GWF Henrietta Combined Cycle Amendment

Soils and Water Resources Data Response Clarifications

The following clarifications are responses to comments provided by Mark Lindley on February 19, 2009 and discussion held between the CEC and GWF on March 3, 2009.

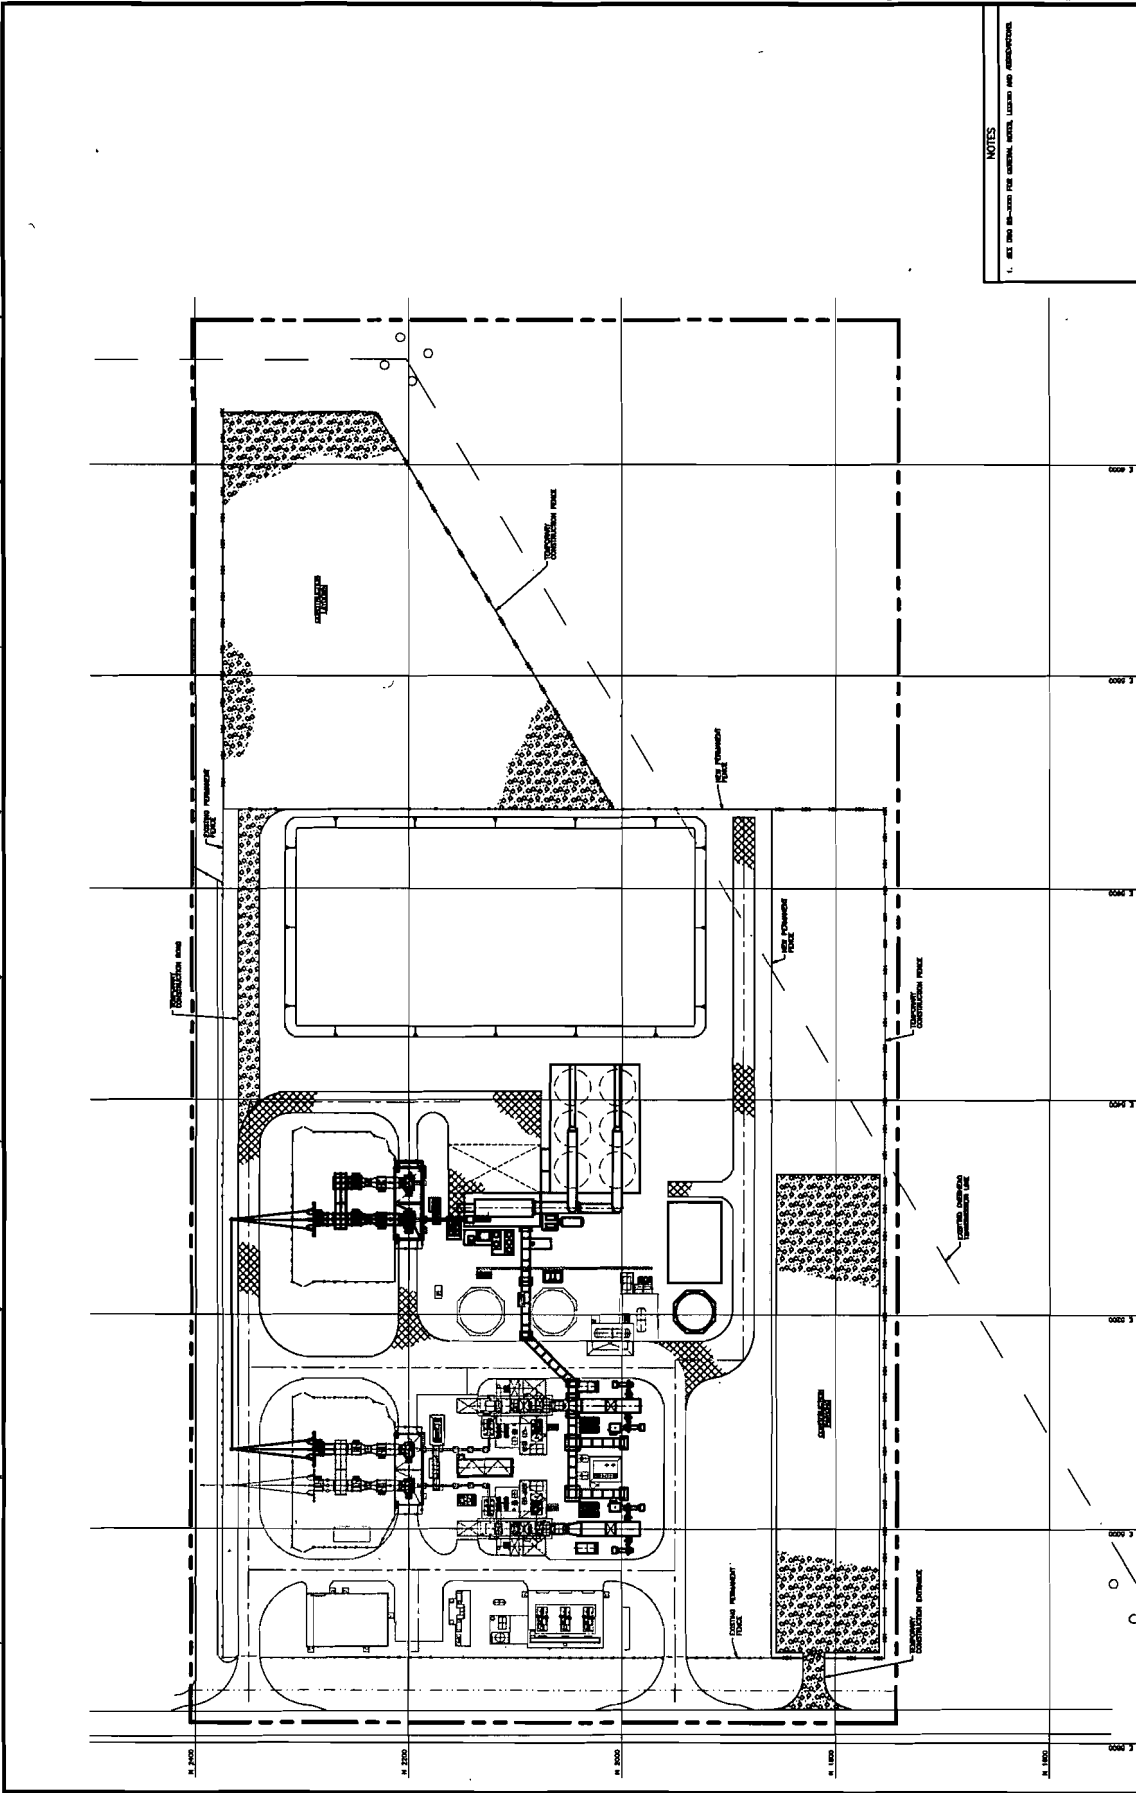
Data Response 29

The contributing watershed has been highlighted in Attachment DR3.2-29. All areas within the permanent fence shall drain to the new stormwater retention basin.

Areas outside of the permanent fence shall be routed away from the site and will not discharge to the stormwater retention basin. Runoff from the construction parking and laydown areas shall be handled under the Construction SWPPP.

Data Response 30

Based on the scaled drawing in Attachment DR3.2-29 it was estimated that the shaded area totaled approximately 409,940 square ft. The stormwater retention basin was sized for a drainage area of 431,244 square ft. The 10 yr – 10 day storm runoff of 4 inches across the site was calculated to total 142,310 cubic feet as shown in Attachment DR3.2-30. The stormwater retention basin volume was sized to contain this volume with 1 foot of freeboard. The final design volume of the basin is 222,278 cubic feet. As a final step, the storm water retention basin was verified to be able to contain the 100 yr-10 day storm runoff event.

The shaded area, which includes all areas within the permanent fence, shall drain to the new storm water retention basin.
